50-280

INFORMATION CONCERNING HIGH DENSITY SPENT FUEL
STORAGE RACKS....INS RESPONSE TO NRC QUESTIONS
SUBMITTED BY LTR DTD 8/25/77.....

FIGURE 4-5

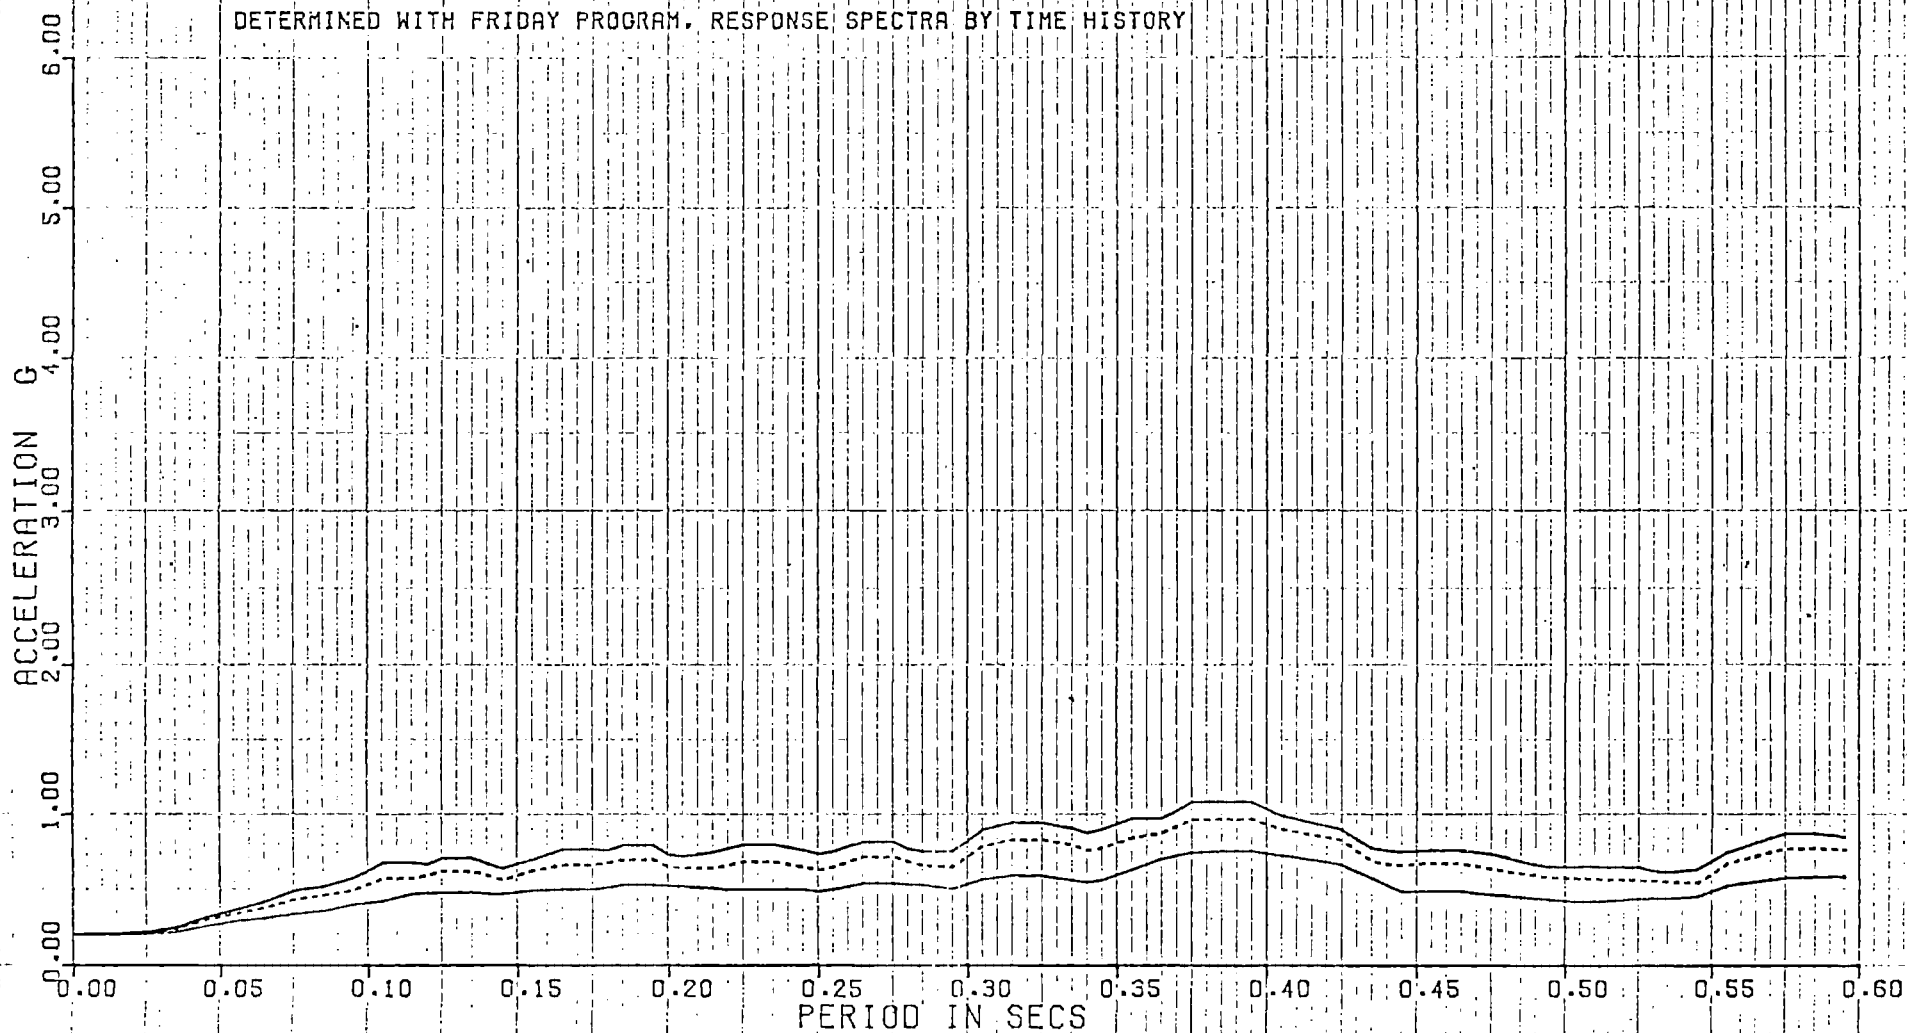
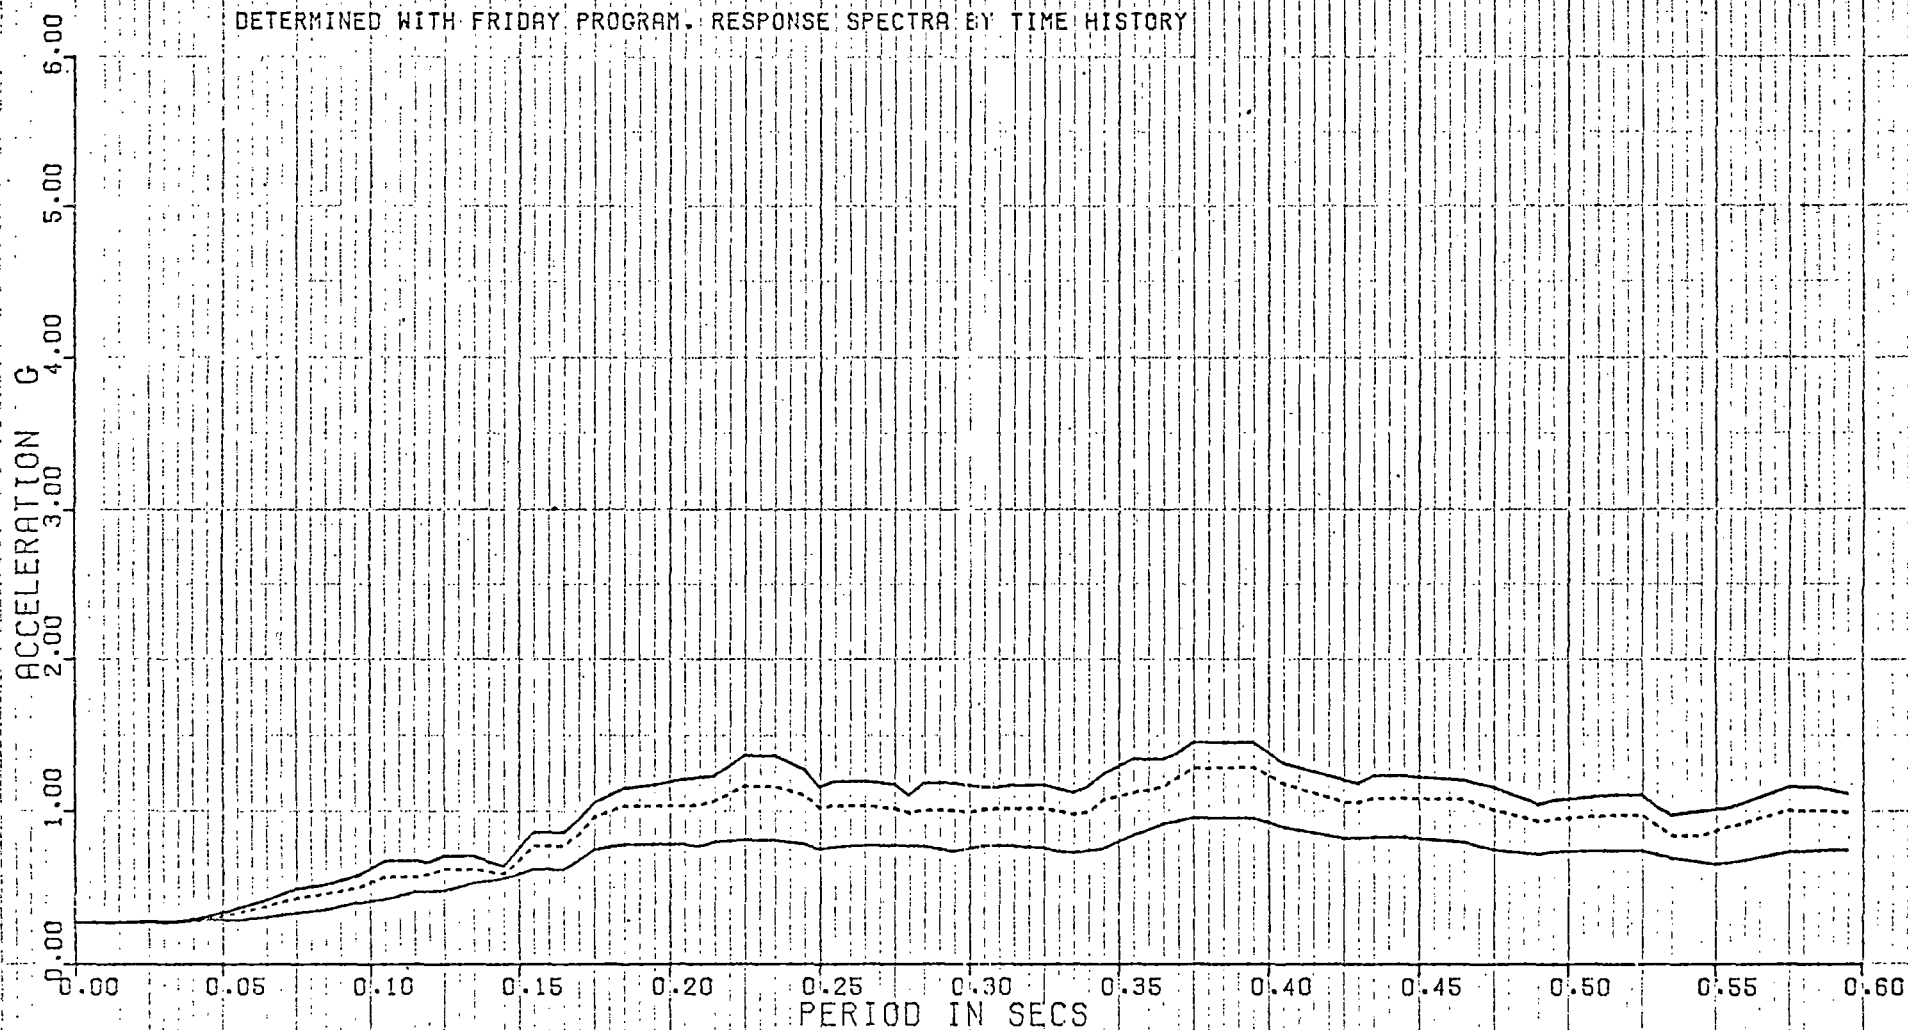
Question 4: In Section 6.3.1.1 it should be clearly stated (SIC) which ground response spectra and amplified floor response spectra were used for this modification indicating the appropriate SSE and OBE values. Also indicate how the allowable stress values for stainless steel at various design temperature were obtained.

Response: The amplified response spectra used in the design of the spent fuel racks are shown in Figures 4-1 through 4-6. The ground acceleration values in section 2.5 of the Surry 1 and 2 FSAR were used to generate these curves. A dynamic model representing the fuel building structure and the subgrade was prepared. This model was used to calculate amplified response spectra (ARS) due to the specified earthquake. ARS were generated for both the Safe Shutdown Earthquake (SSE) and the Operational Basis Earthquake (1/2 SSE) at the mat surface, the top of the concrete structure, and the roof of the steel superstructure. The response spectra of the design earthquakes used are consistent with the requirements set forth by NRC Regulatory Guide 1.60, and the damping levels are from NRC Regulatory Guide 1.61.

The dynamic analysis was performed for a range of subgrade properties to account for uncertainties in soil parameters. The ARS provided are the result of enveloping the response spectra obtained from these analyses. They also include the design ground response spectrum.
